Agenda – Council – May 16, 2019

Item No. 7 Rezoning – 717 Jessie Avenue
(Fort Rouge – East Fort Garry Ward)
File DAZ 209/2018 [c/r DAV 146122/2018D]

Title: DAZ 209/18 at 717 Jessie Ave.

Issue: For consideration at the public hearing to rezone the property at 717 Jessie Ave. to the "RMF-S" district to establish a four (4) unit multi-family residential use.

1 SITE PLAN
A-0 3/32" = 1-0"

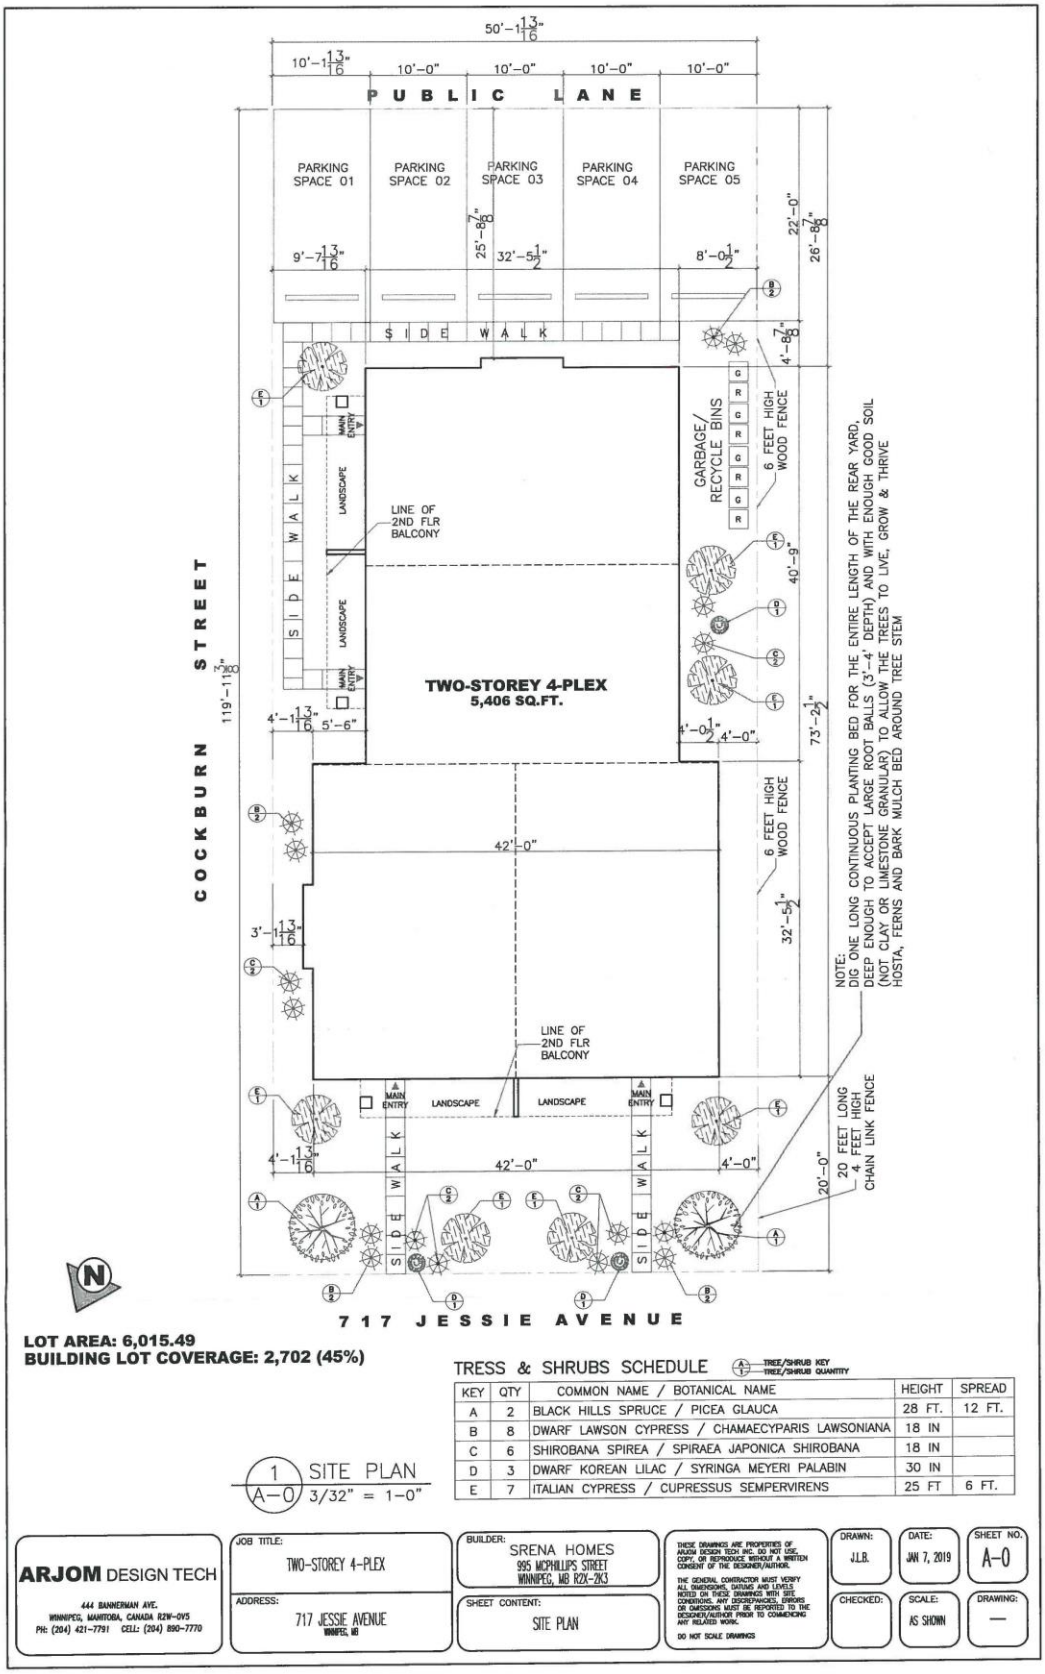
x) Front yard fences and walls should be no higher than 1 m and be of primarily transparent construction	**Modification needed**	Through a condition on DAV 18-146122D, the Urban Planning Division will require that front yard fences shall not exceed 1 metre in height and shall not be chain link.

xvii) All parking lots should provide appropriate screening to preserve the residential character of the area	**Yes**	The proposed development is locating parking at the rear of the property. A six (6) foot tall wood fence will screen the parking area from adjacent residential uses.
xviii) Residential developments should provide pedestrian access at street level and locate parking, loading, and service entrances at the rear of buildings.	**Yes**	Proposed development has at grade access from both public streets. Sidewalk connections are illustrated from Jessie Ave to the main entrance. Sidewalks will also be provided from the parking area to the side suite entrances on Cockburn Ave.
xix) Residential development should have consideration for light, view, and privacy of adjacent buildings and area	**Yes**	The proposed building is lower than permitted in this area of the COAP. There are no balconies facing the interior side yard. The proposed dwelling maintains a 4 foot interior side yard for 32 feet of the building. After 32 feet, of building length, the side yards increase to 8 feet providing increased separation.

xxiii) Residential development should encourage preservation of mature canopy shade trees and natural areas through good design	**Yes**	Arborist report has been submitted. Two large trees at front of property are intended to be saved.
xxiv) Residential design should strongly encourage the incorporation of concepts of Universal Design and Crime Prevention Through Environmental Design (CPTED) into building, streetscape, and site design	**Yes**	Building elevations facing public streets consist of active uses including entrances, windows and balconies providing increased “eyes on the street” in a fashion consistent with CPTED principles.,
